2017 Ford Mustang V8-5.0L

TSB 16-0103	MANUAL TRANSMISSION - NO CRANK - BUILT ON OR BEFORE 6/15/2016
<b>Publication Date: August 10, 2016</b>

Figure 1 - 16-0103

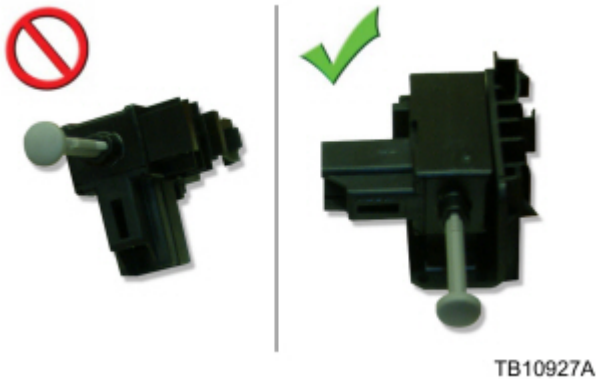
Some 2015-2017 Mustang vehicles equipped with a manual transmission and built on or before 6/15/2016 may exhibit a no crank condition due to the clutch pedal position (CPP) switch being damaged.

1. Inspect the CPP switch for physical damage. Is the CPP switch damaged?
  - a. Yes - proceed to Step 2.
  - b. No - this article does not apply.
2. Install a new CPP switch and bracket. Refer to Workshop Manual (WSM), Section 303-14. The switch includes a plastic bracket rotating the connector 90 degrees. (Figure 1)
